Response to
Request for Additional Information No. 448(4898, 5084)
Supplement 9

U.S. EPR Standard Design Certification
AREVA NP Inc.
Docket No. 52-020
SRP Section: 03.08.01 - Concrete Containment
Application Section: 3.8.1

Question 03.08.01-51:**Follow-up to RAI 155, Question 3.8.1-22**

Figure 03.08.01-51-1—Coarse Slice Model Mesh Density (a) Typical RCB Section (b) Typical RCB Dome (c) Typical RCB Wall

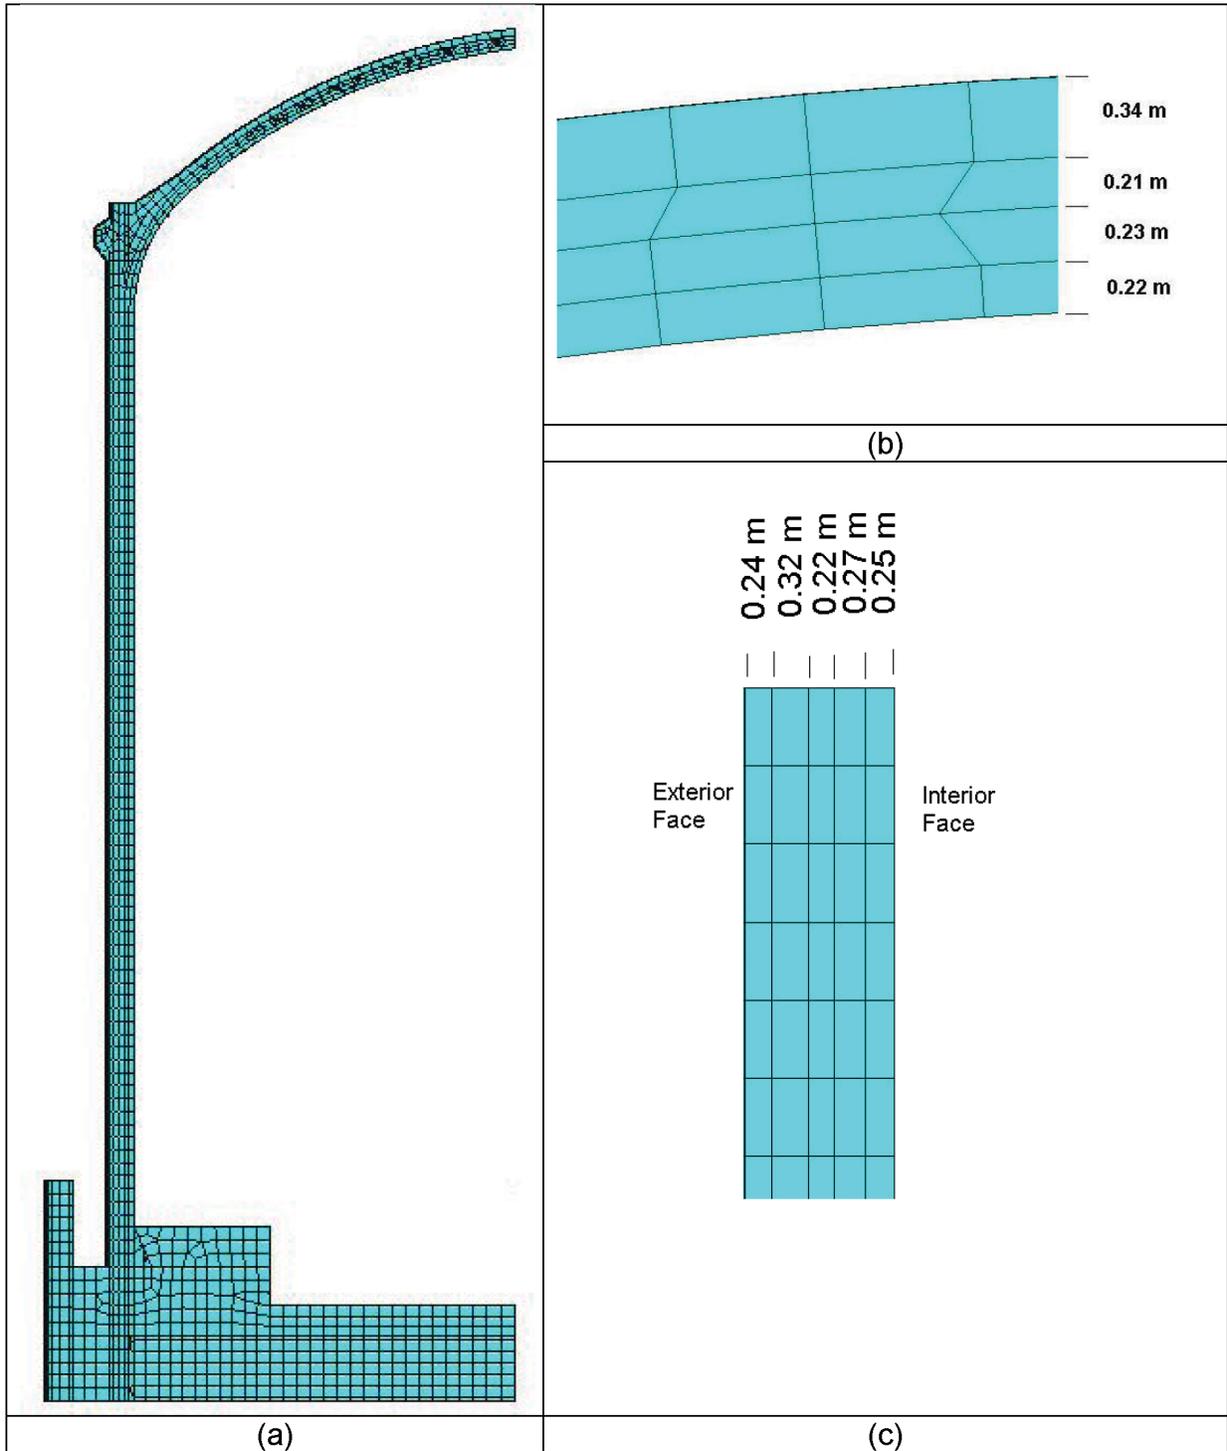
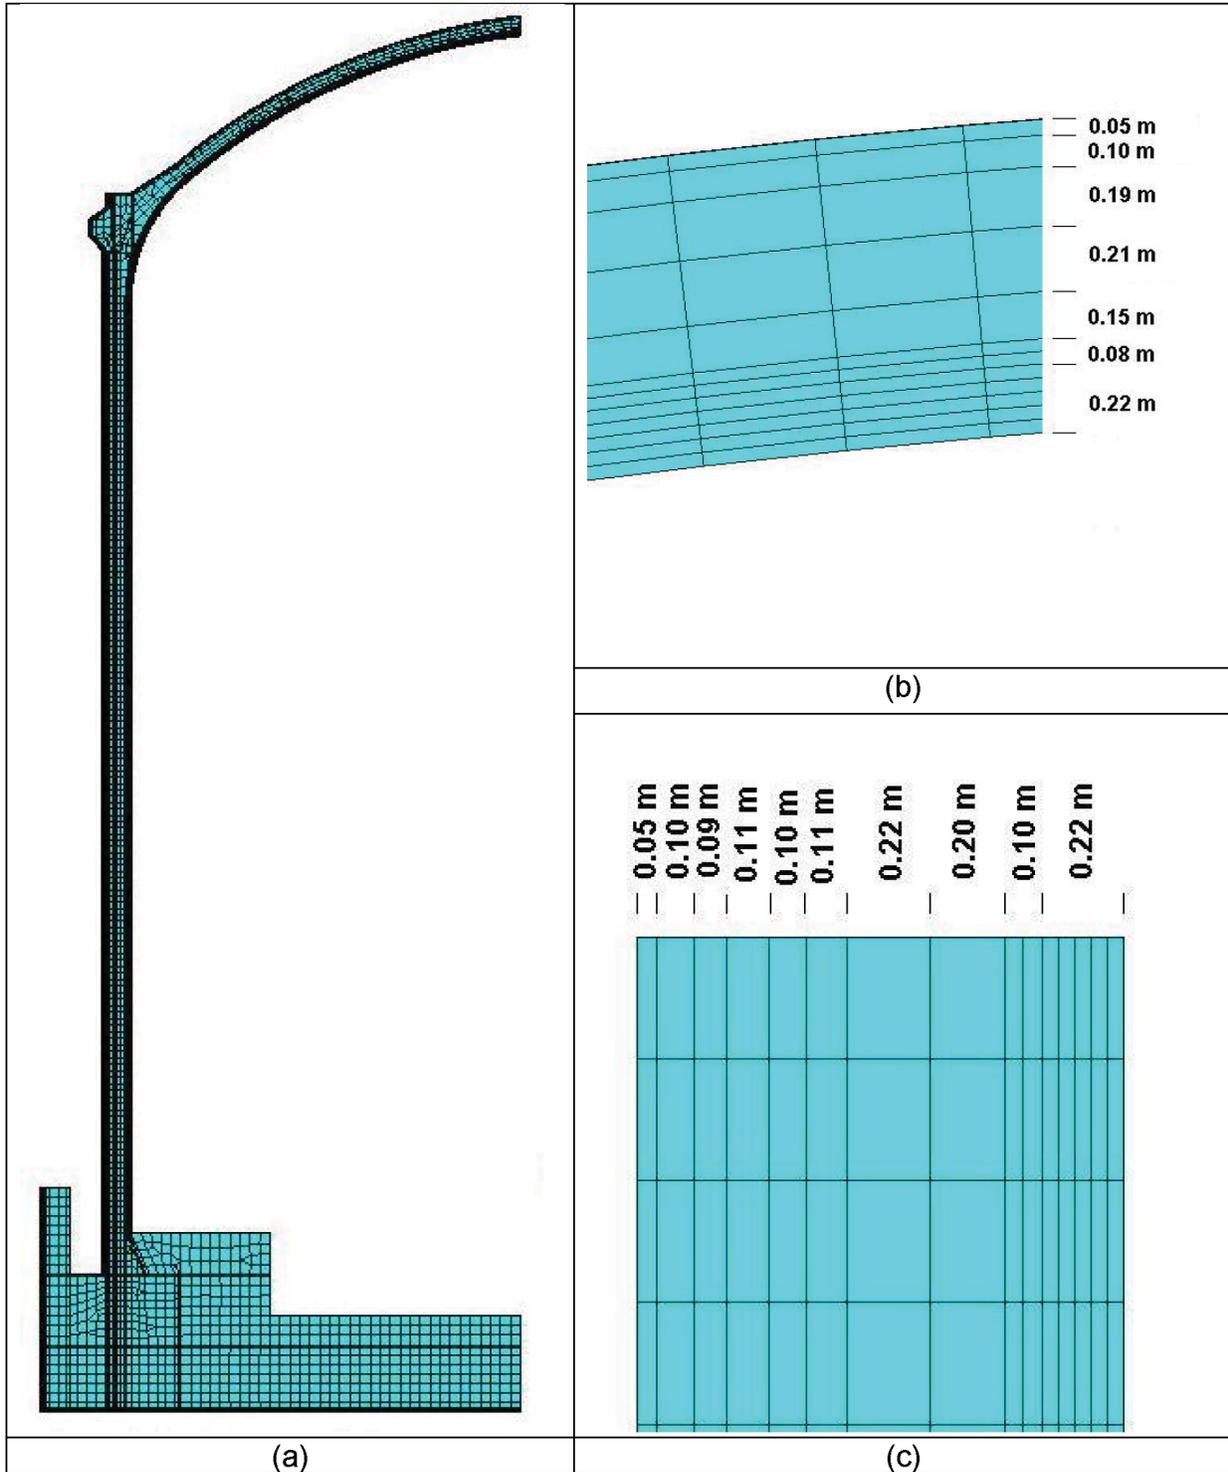
- a. The RAI response states that the mesh density in the 6-degree slice FEM model is increased to calculate the change in thermal moments due to mesh refinement. Provide a description of this mesh refinement, include a figure of each model, and identify the relative sizes of the original vs. the refined mesh.

In response to RAI 03.08.01-22, six-degree slice finite element model (FEM) models were considered with a coarse mesh density and refined mesh density. The slice model with coarse and refined mesh densities are referred to as “equivalent slice model” and “refined slice model,” respectively. The equivalent slice model has similar element thickness and mesh density as the Nuclear Island (NI) static model RCB, and contains five and four elements through thickness of the RCB wall and dome, respectively. The refined slice model has 15 and 12 elements through thickness of the RCB wall and dome, respectively. The equivalent and refined slice models are used for linear structural analysis of the model.

Figure 03.08.01-51-1 and Figure 03.08.01-51-2 show mesh densities of the RCB wall and dome for equivalent and refined slice models.

Figure 3.8-20—Accident Temperature versus Time (Reactor Containment Building)

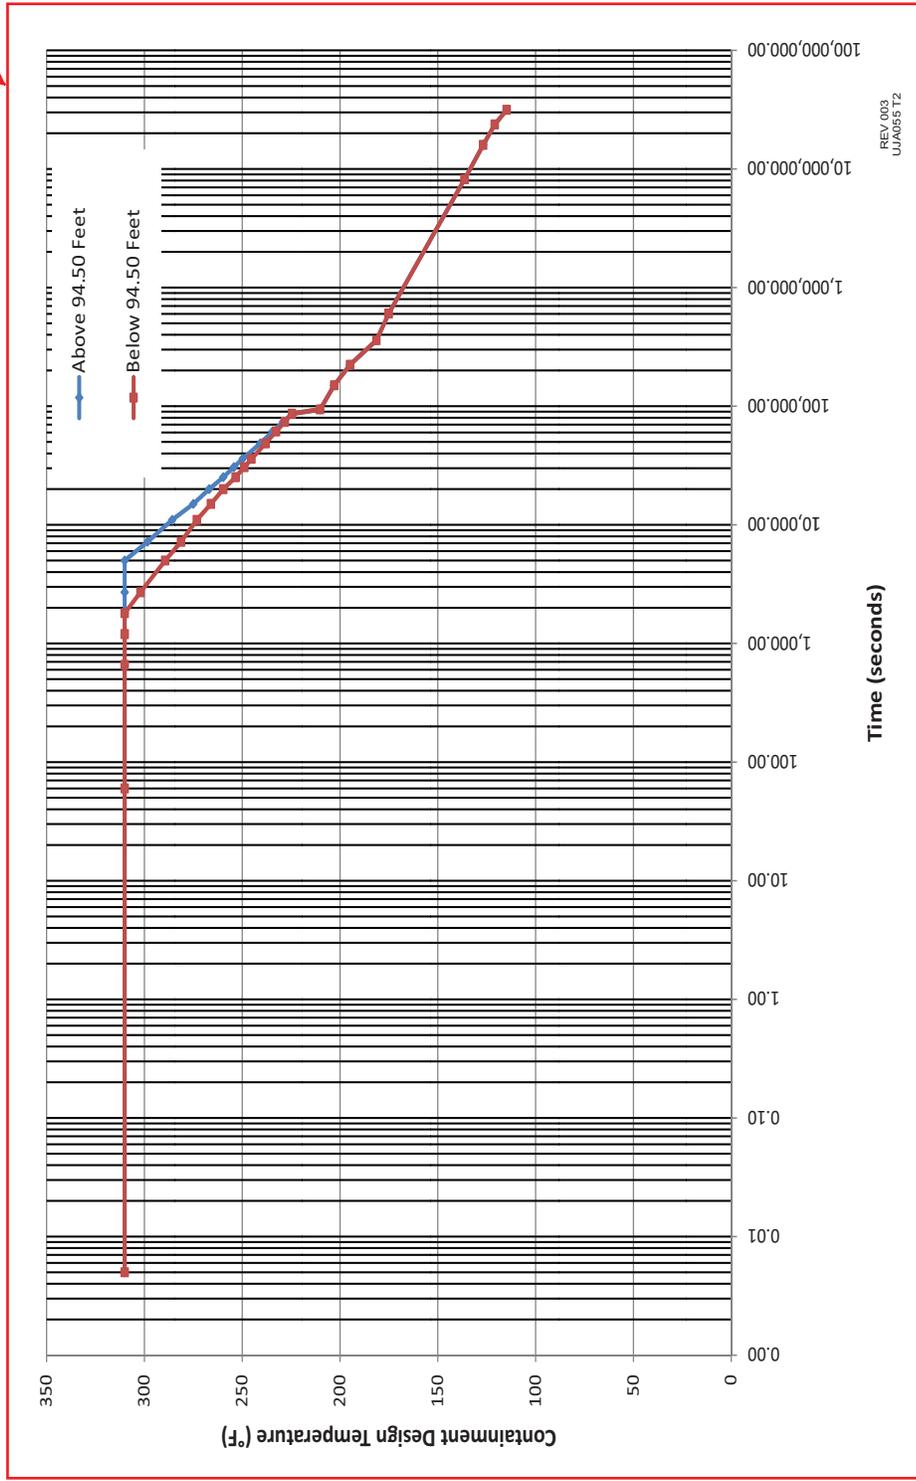
- f. Explain how the thermal loads are applied to the nonlinear FEM model. The RAI response simply states that “the model is subjected to accidental pressure loads,” or “the model is subjected to accidental temperature and pressure loads.” However, it is not clear whether the analysis considered the variation of the temperature gradient across the containment thickness at the four critical time points identified in the temperature and

U.S. EPR FSAR Tier 2, Section 3.8.1.4.5, Figure 3.8-20 through 3.8-24 will be revised as described in the response and indicated on the enclosed markup. A portion of the U.S. EPR FSAR changes associated with this response have already been included in Revision 3. Other portions of the FSAR changes will be incorporated into Interim Rev. 4 as identified in the FSAR markups.
